ACCESS REPORT

PROJECT: **New High School for Googong**
PROJECT NO: **GDL240470**
PREPARED FOR: **NSW Department of Education**
REVISION: **E**
DATE: **5.02.2025**

| Revision | Date | Details | Authorised | |
|----------|------------|---|--|---|
| E | 5.02.2025 | Schematic Design review updated with comments | Prepared: Bonnie Chang, Access Consultant |  |

Drawing Reference
GGHS-NBRSt-B00A-L3-DR-A-11003
 Revision **9**

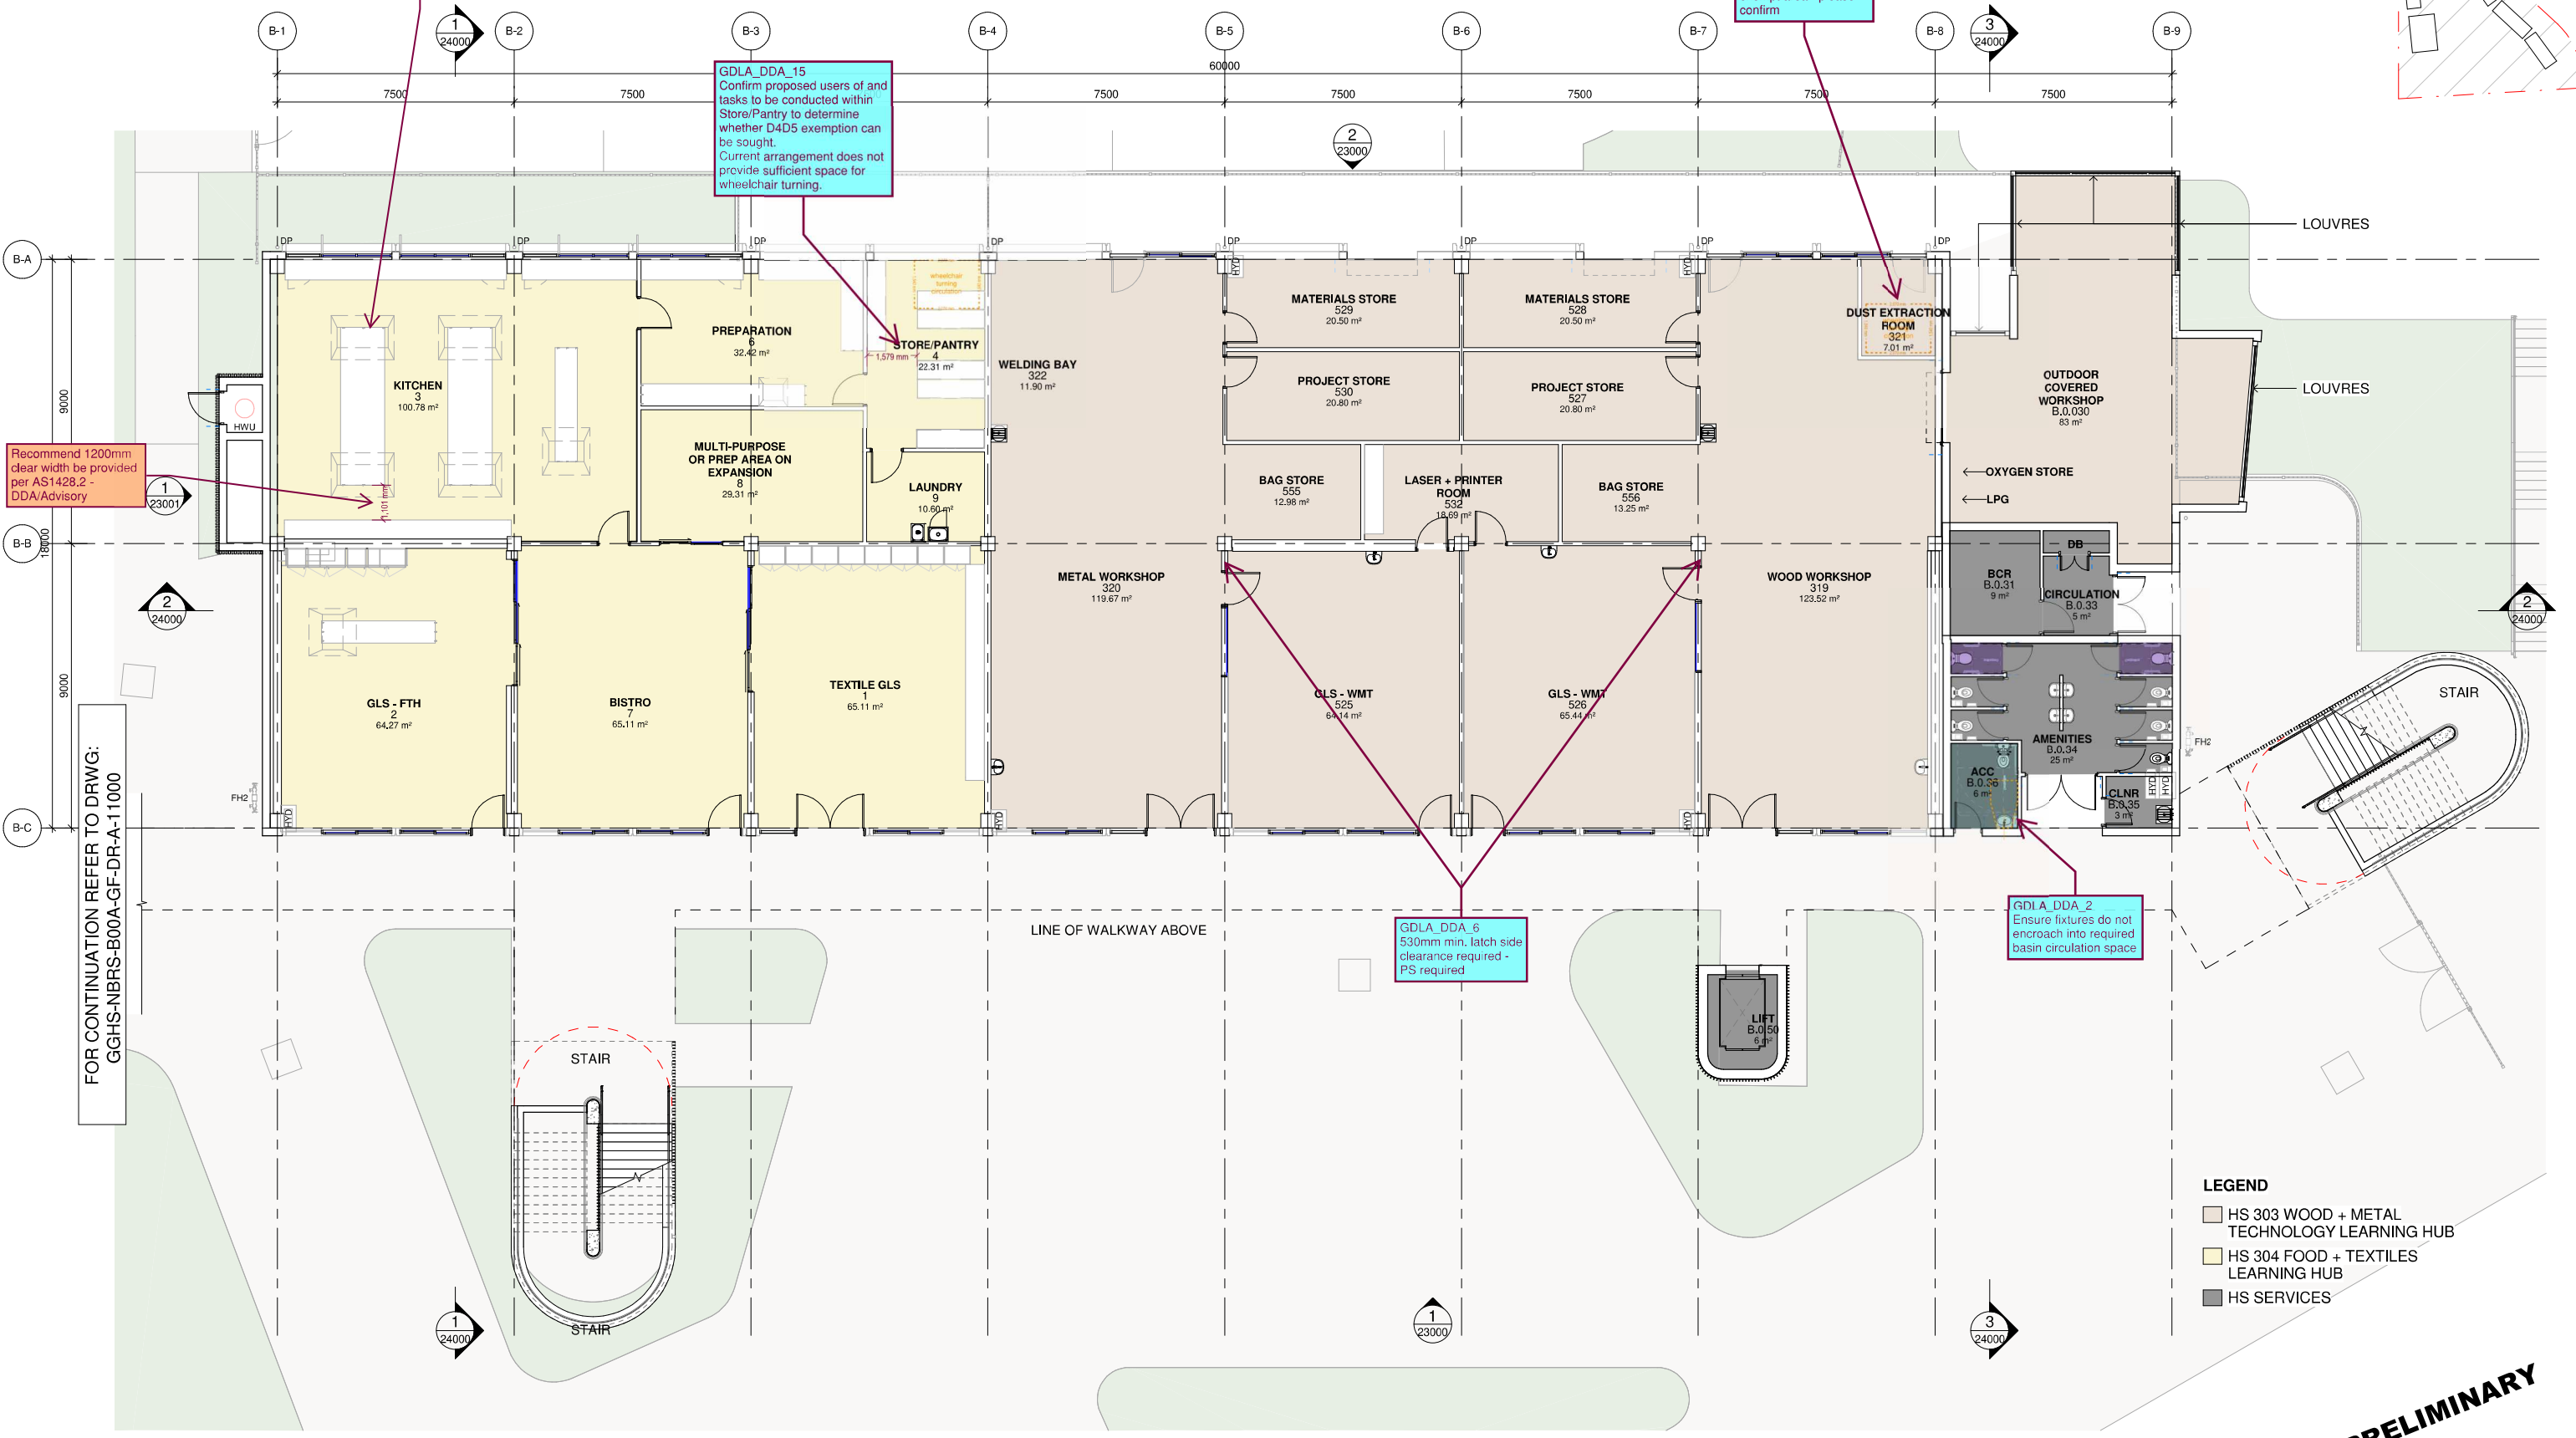
Consideration for at least 1 x accessible Kitchen station to be provided with appropriate height, underbench clearance and accessible reach range to key facilities using AS1428.2 design guidance for equity - DDA Advisory

GDLA_DDA_15 Confirm proposed users of and tasks to be conducted within Store/Pantry to determine whether D4D5 exemption can be sought. Current arrangement does not provide sufficient space for wheelchair turning.

GDLA_DDA_15 Assumed Part D4D5 exempt area - please confirm

Drawing Title
BLOCK B - STAGE 1 - LEVEL 2

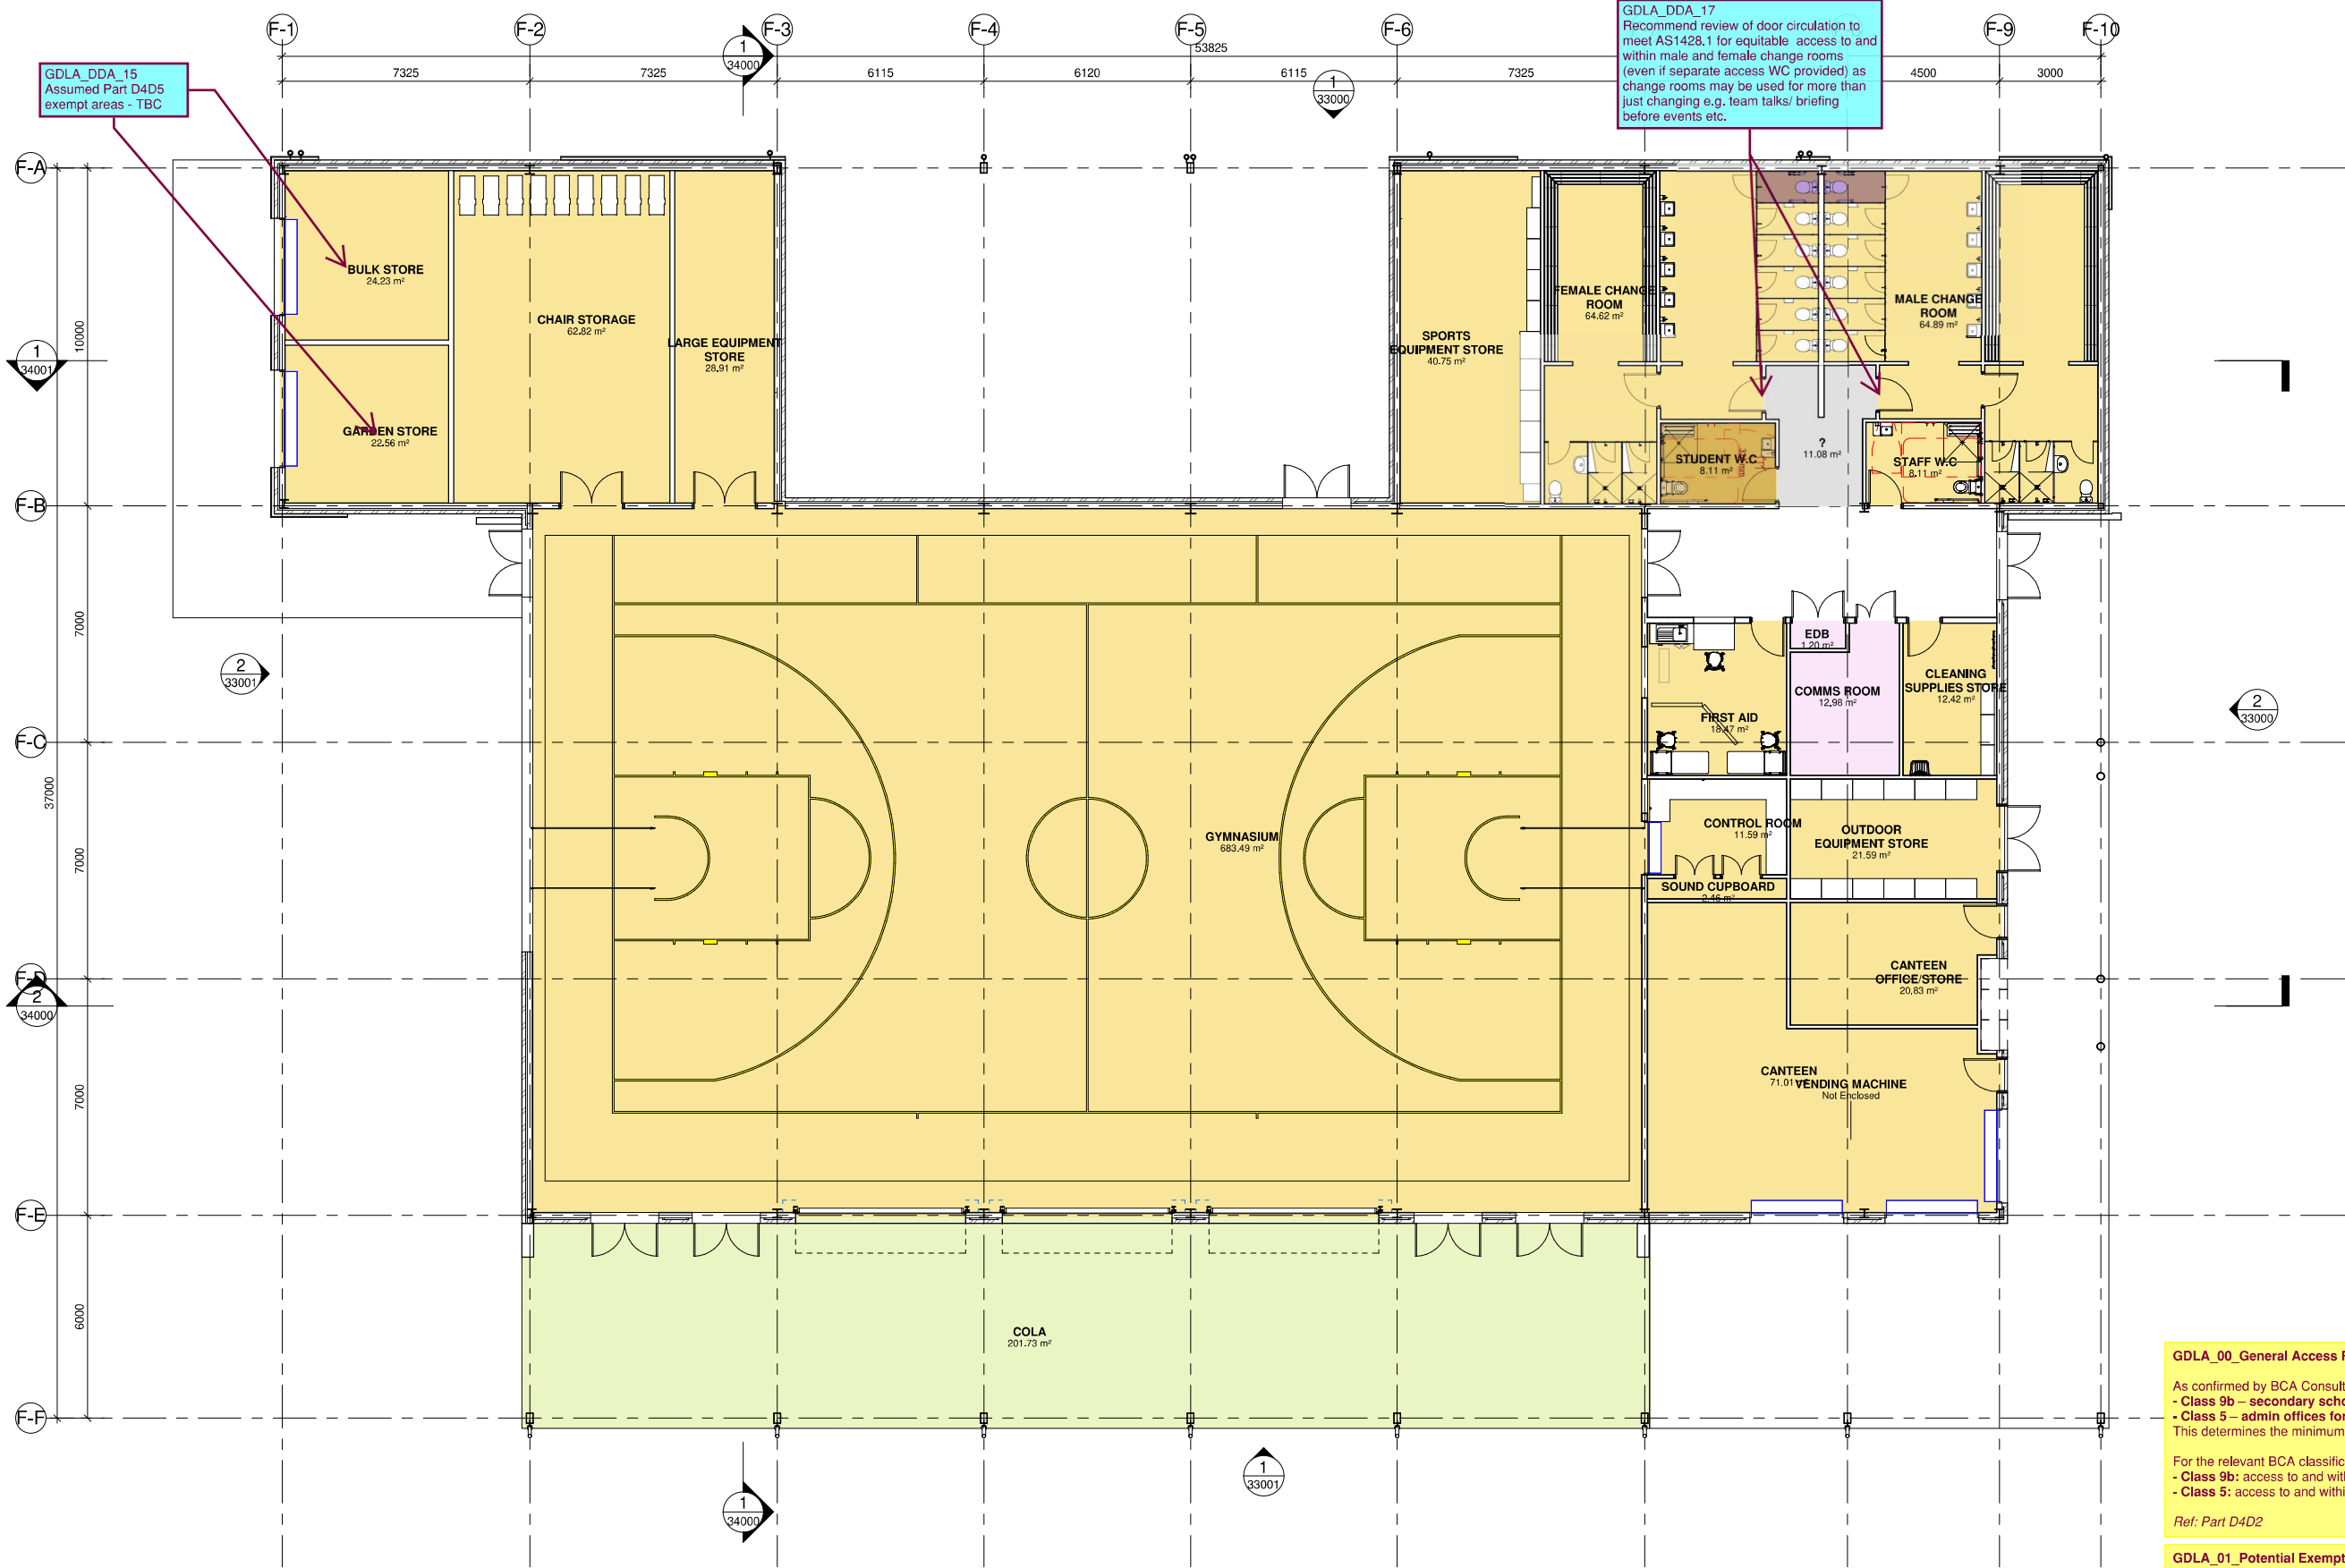
GDLA_DDA_17
 Recommend review of door circulation to meet AS1428.1 for equitable access to and within male and female change rooms (even if separate access WC provided) as change rooms may be used for more than just changing e.g. team talks/briefing before events etc.
